TECHNICAL DRAINAGE STUDY UPDATE No.4

Skye Canyon
(Phase 2 Infrastructure)
City of Las Vegas, Nevada

Subject: Technical Drainage Study Update No.4 for Skye Canyon Ph.2 Infrastructure

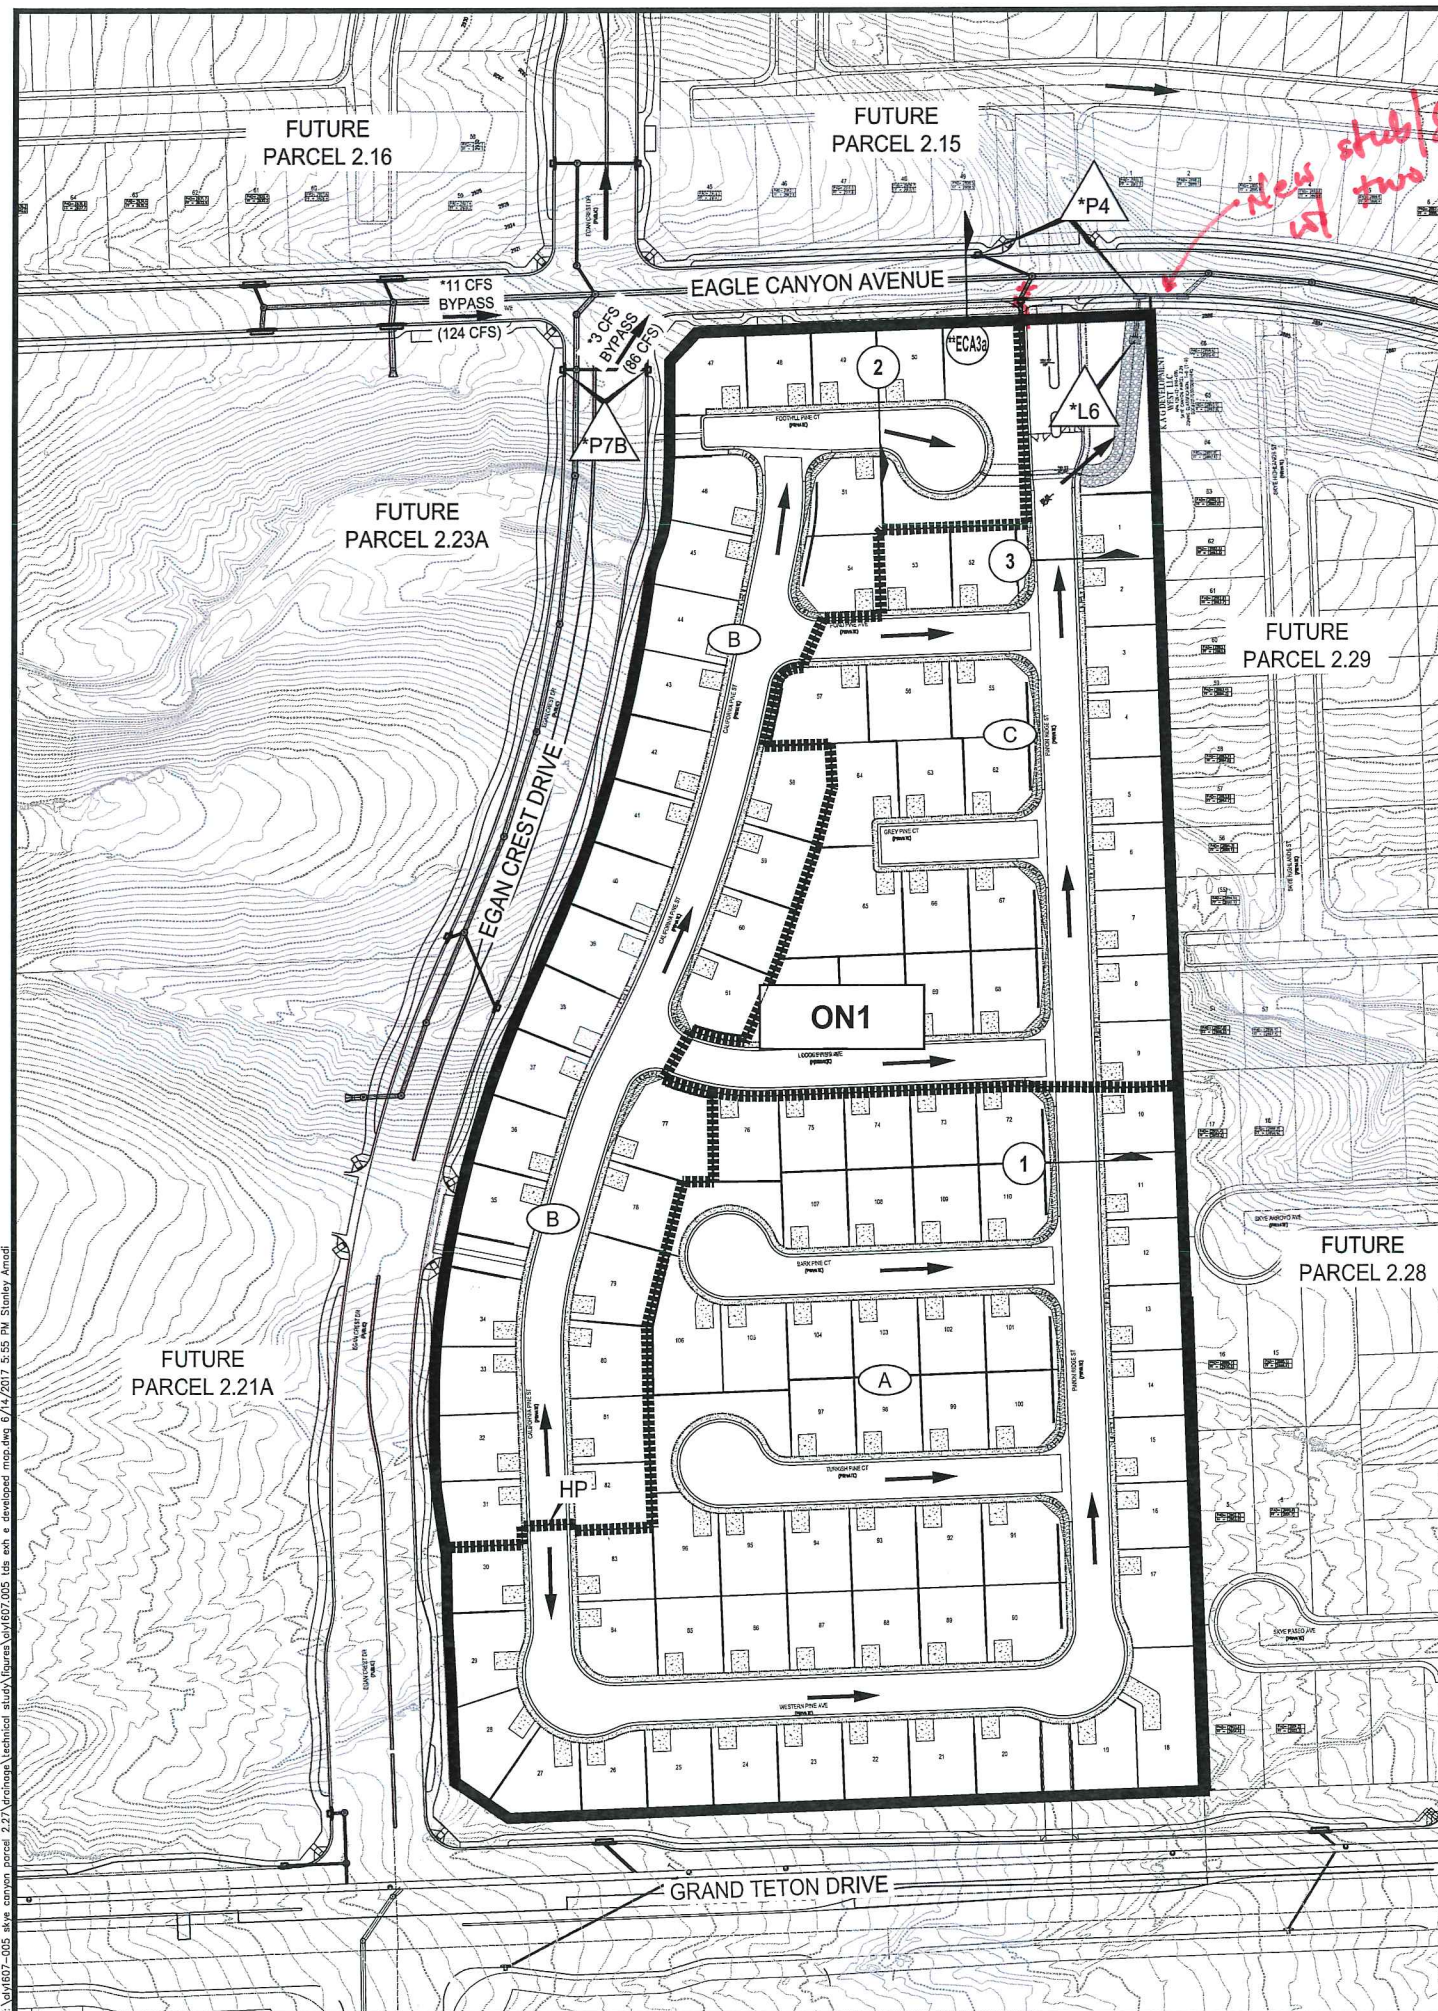
53 cfs generated by the site is greater than 49 cfs anticipated by the Master Study. Also the Due to drainage area discrepancy. Also, Stub Connection for flume is relocated. Thereby, Eagle Canyon mainline SD is updated to reflect new connection and revised flow rate
